SERVICE BULLETIN

M-1267

883 CYLINDER LINER CHANGE

Figure 1. Earlier 883 Cylinder with Steel Cylinder Liner

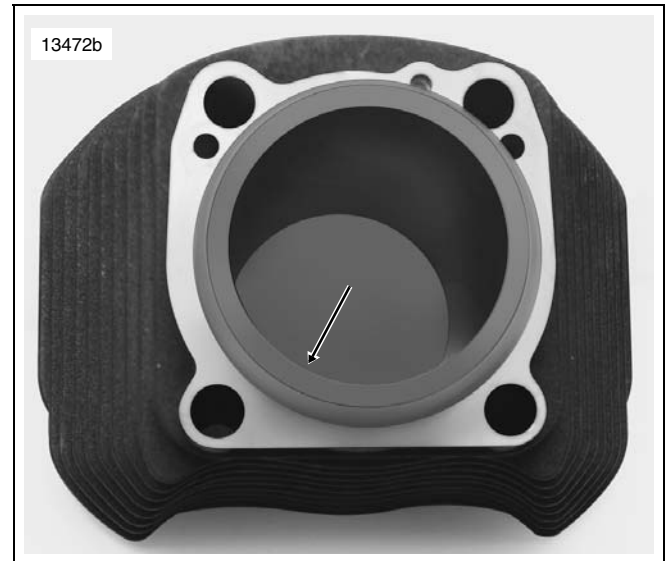
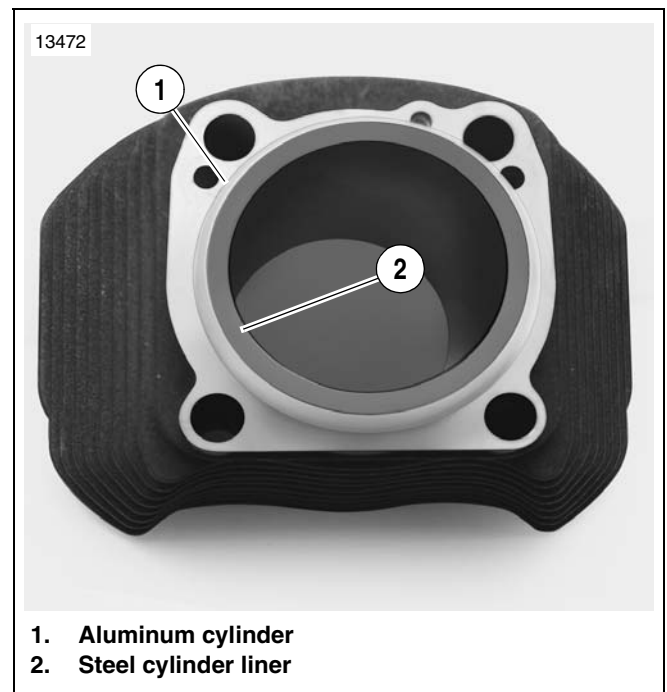
The purpose of this bulletin is to inform dealers and technicians that XL 883 cylinders can no longer be bored out to fit 1200 pistons. The 883 cylinder changed to a thinner liner which does not allow for boring to accommodate 1200 pistons.

If a customer chooses to convert an 883cc Sportster to 1200cc displacement by boring existing cylinders, first inspect the 883 cylinders to determine if they allow adequate liner thickness to be bored. See Figure 1. Earlier cylinders have a full steel liner extending from the base. See Figure 2. Later cylinders have an aluminum portion extending from the base with a steel insert.

- The new cylinders may be bored and fitted for oversized 883 pistons listed in the parts catalog.
- If you attempt to bore a later 883 cylinder to 1200, enough material will be removed from the steel cylinder liner to render the cylinder unserviceable. The thinner cylinder liner does not allow for boring to accommodate the 1200 piston.
